CIMARRON CORPORATION

Re: Docket No. 70-925; License No. SNM-928
Addendum to June 2, 2008 License Amendment Request

**Bioremediation
 Implementation Process**

FIGURE
5-1

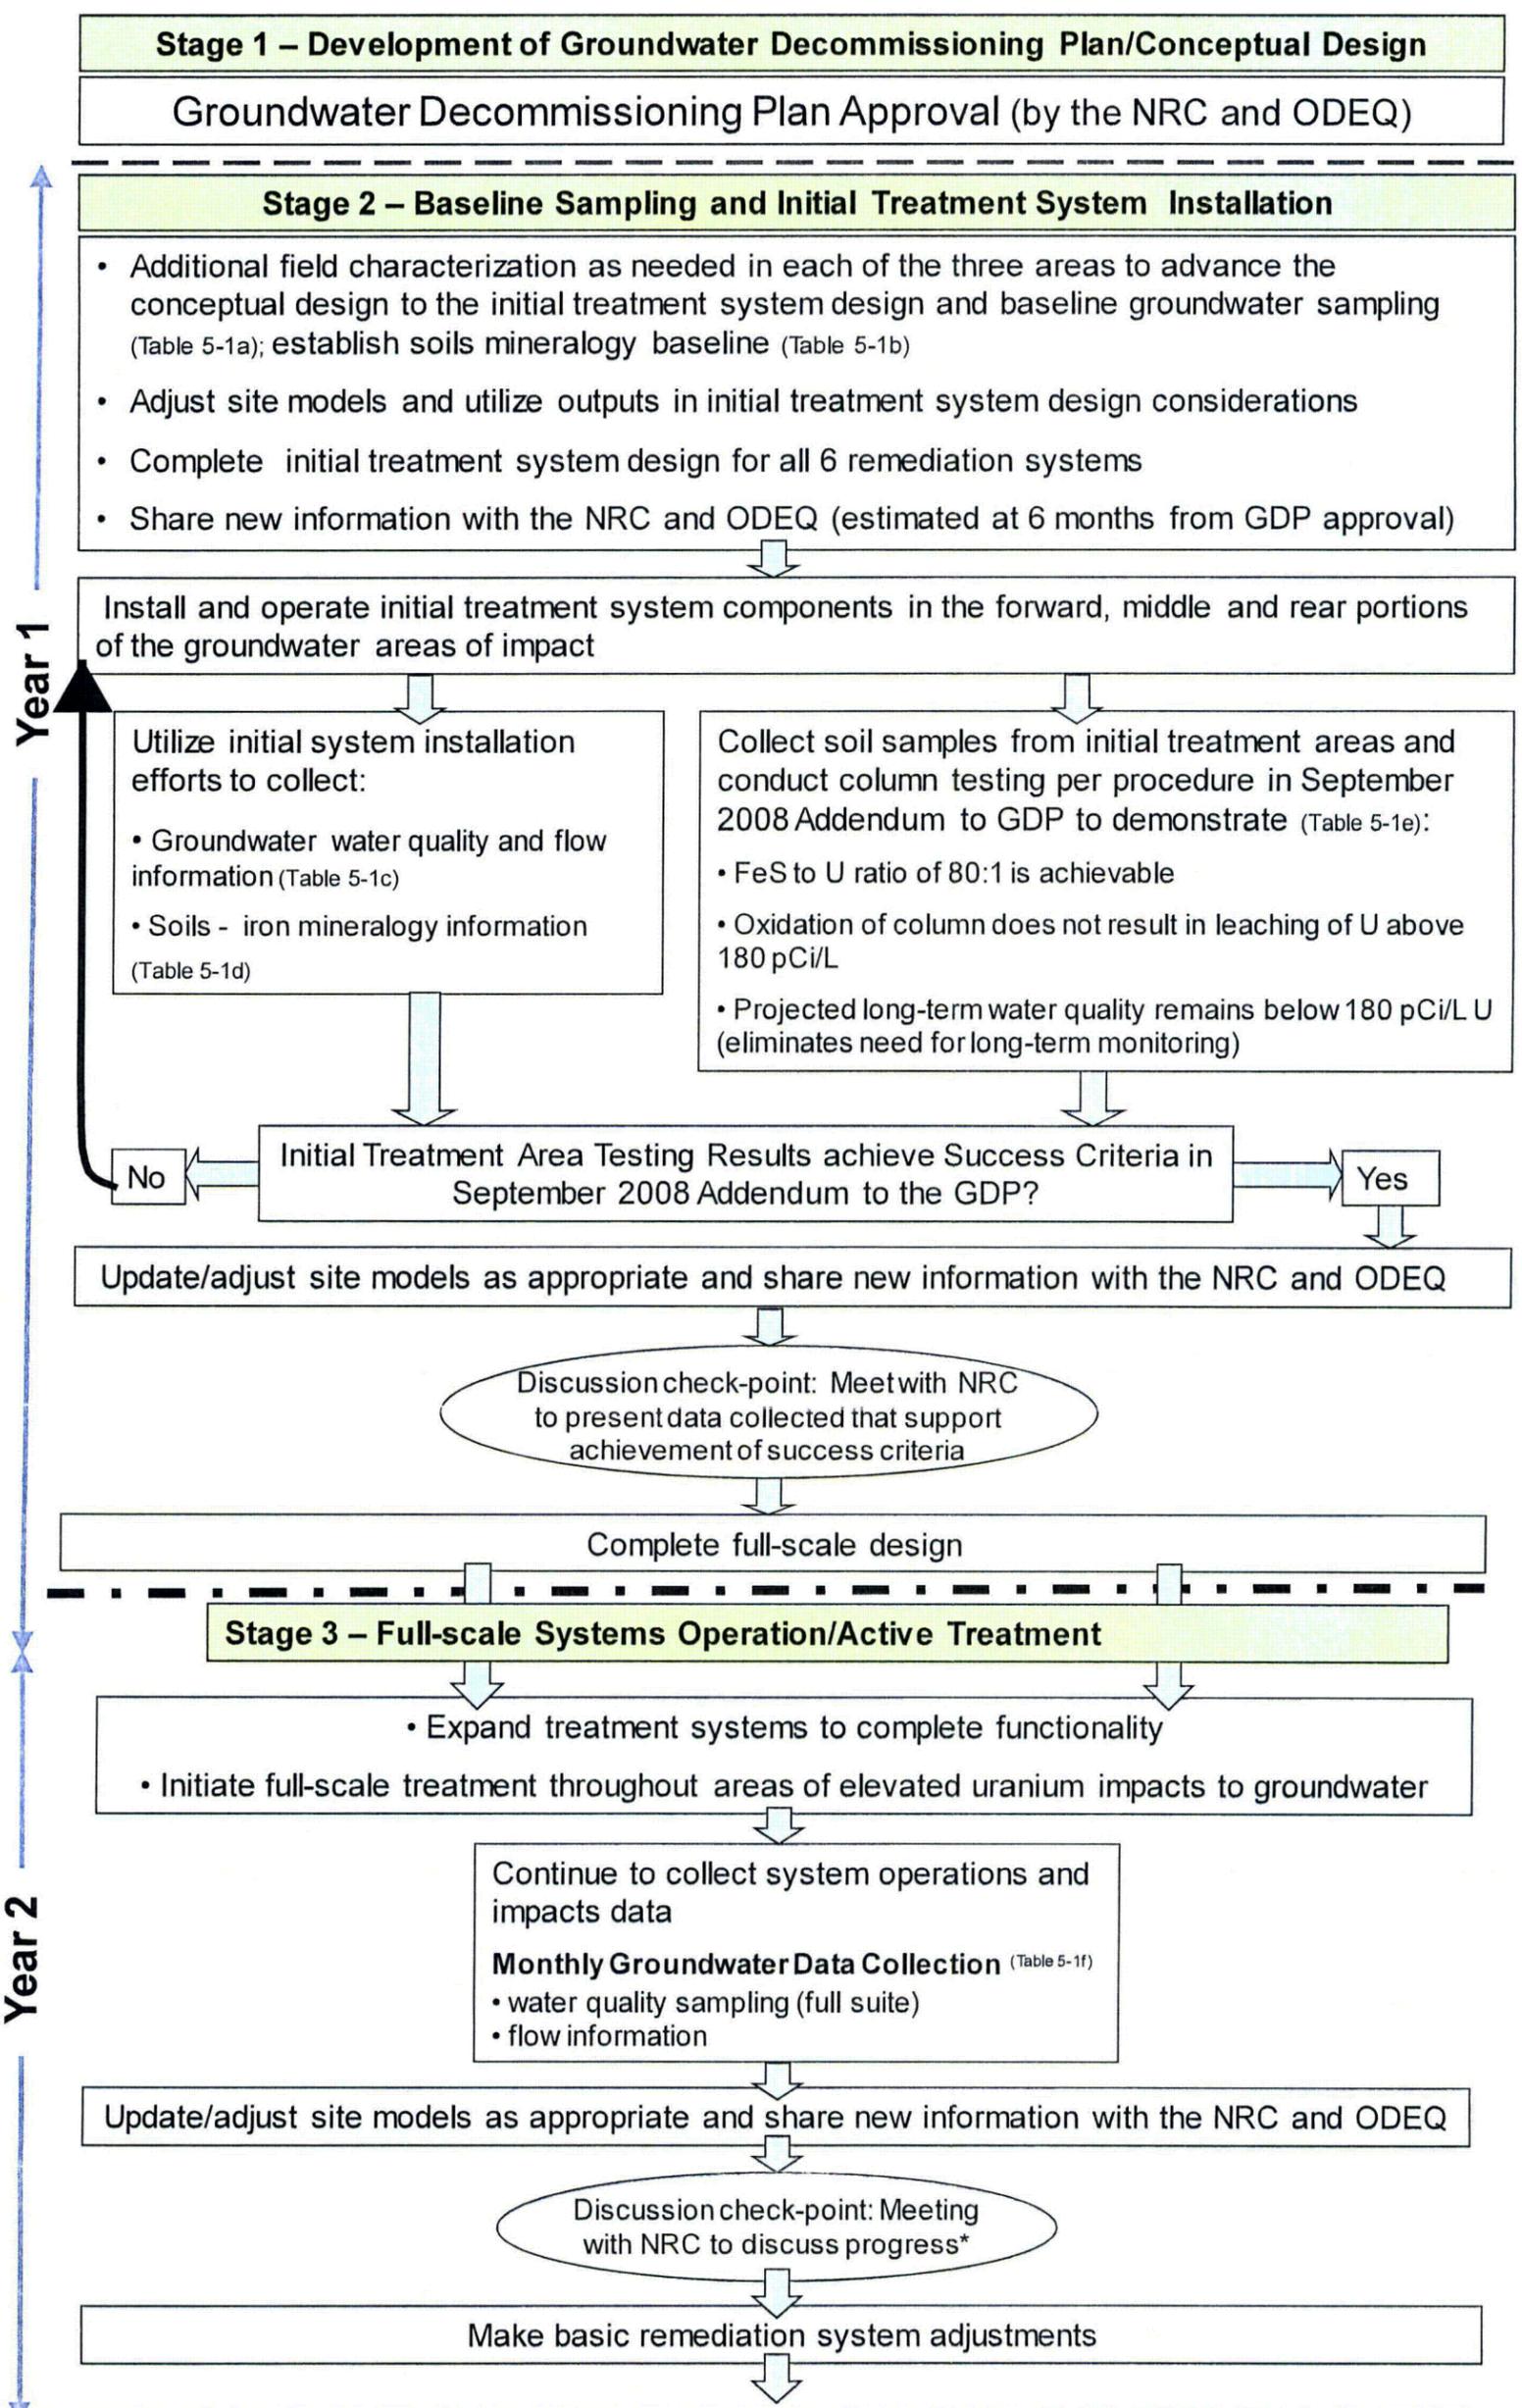
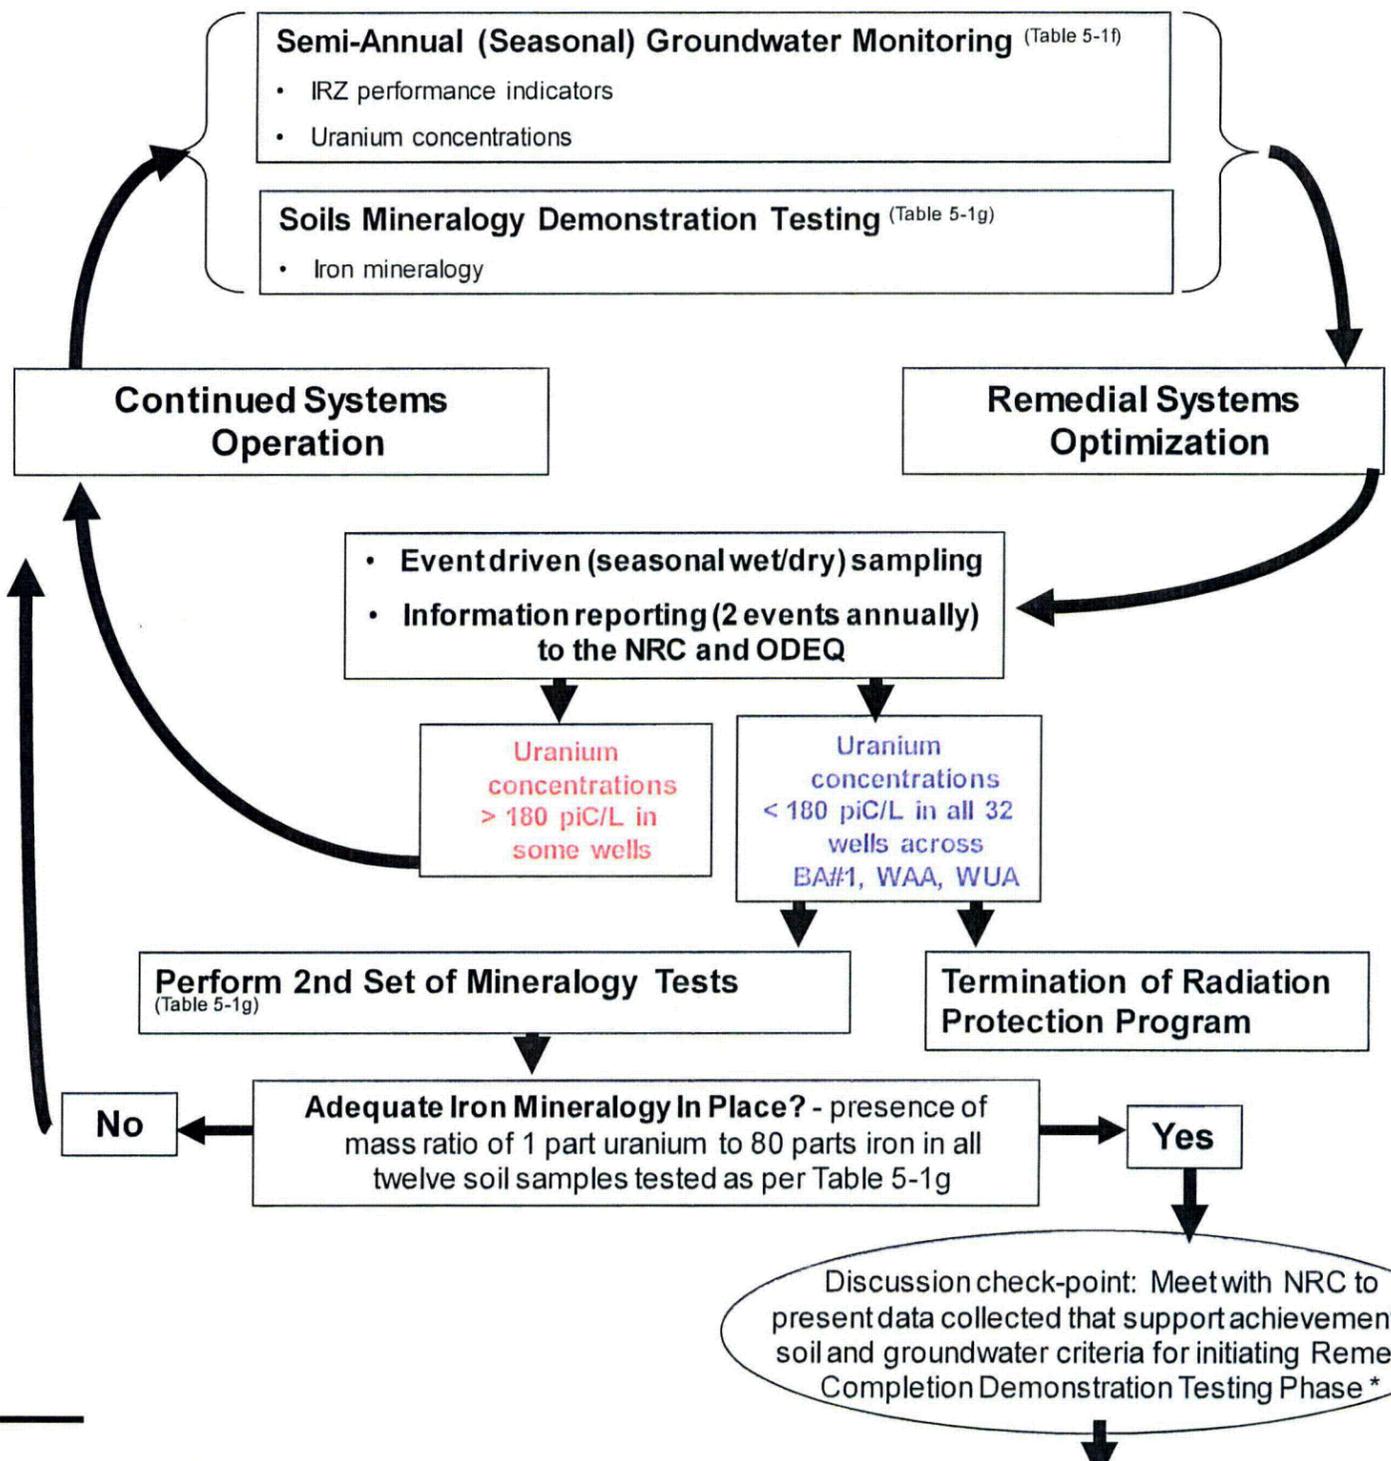
A revised Bioremediation Implementation Process Figure (Figure 5-1) is attached, summarizing the agreed-upon steps in the bioremediation process. Figure 5-1 also includes Table 5-1 which summarizes all of the data to be collected during the bioremediation process. This figure is intended to replace Figure 5-1 in the June 2, 2008 license amendment request.

Revisions to Figure 5-1: In conversations with NRC subsequent to the submittal of the September 4 Addendum to the LAR, it was requested that additional opportunities be made available for the presentation to NRC of relevant field data. These are indicated on Figure 5-1 as “Discussion Check-Points”. It should also be noted that upon initiation of the field work, baseline groundwater and soil sampling will be performed and the geochemical model will be updated in light of this data set. This information will be used to refine the design of the initial treatment area system installation, and the data and the model update will be shared with the NRC.

Additional clarification was provided on Figure 5-1 for the criteria that must be satisfied to achieve license termination. These include the following:

- A. Eight quarters of groundwater monitoring results with U below 180 pCi/L and no increasing trends based on EPA statistical evaluation methods (Mann-Kendall test/Sen’s estimate of slope).
- B. A round of soil sampling to confirm the presence of iron to uranium ratio of at least 80:1 completed at the end of the Remedy Completion Demonstration Testing phase.
- C. Geochemical modeling results updated with site-specific data to demonstrate the 1000-year stability of the remedy.
- D. Column testing results that show that reoxidation of the aquifer will not result in remobilization of the uranium above the criteria (from column testing completed during the initial treatment area phase).

It should be noted that with respect to A, prior to the initiation of eight quarters of groundwater monitoring (during the formal “Remedy Completion Demonstration Testing” phase), two to three years of groundwater monitoring will have been conducted to confirm that all wells have U concentrations below 180 pCi/L prior to discontinuing active remediation. However, the eight quarters of sampling is consistent with EPA procedures for a robust groundwater data set to support decisions about remedy effectiveness. In addition, with respect to B., additional soil sampling will be performed prior to the final sampling as noted in Figure 5-1 and Table 5-1 (5-1g). The soil data set in its entirety, and changes in soil mineralogy that occur during and up to the final sampling phase, will be considered in the updated geochemical modeling described in C. Finally, as described in Condition #4, results of the analysis of soil mineralogy during the column testing will be compared to the tests of soil mineralogy in field collected samples so that markers of uranium immobilization longevity can be identified.
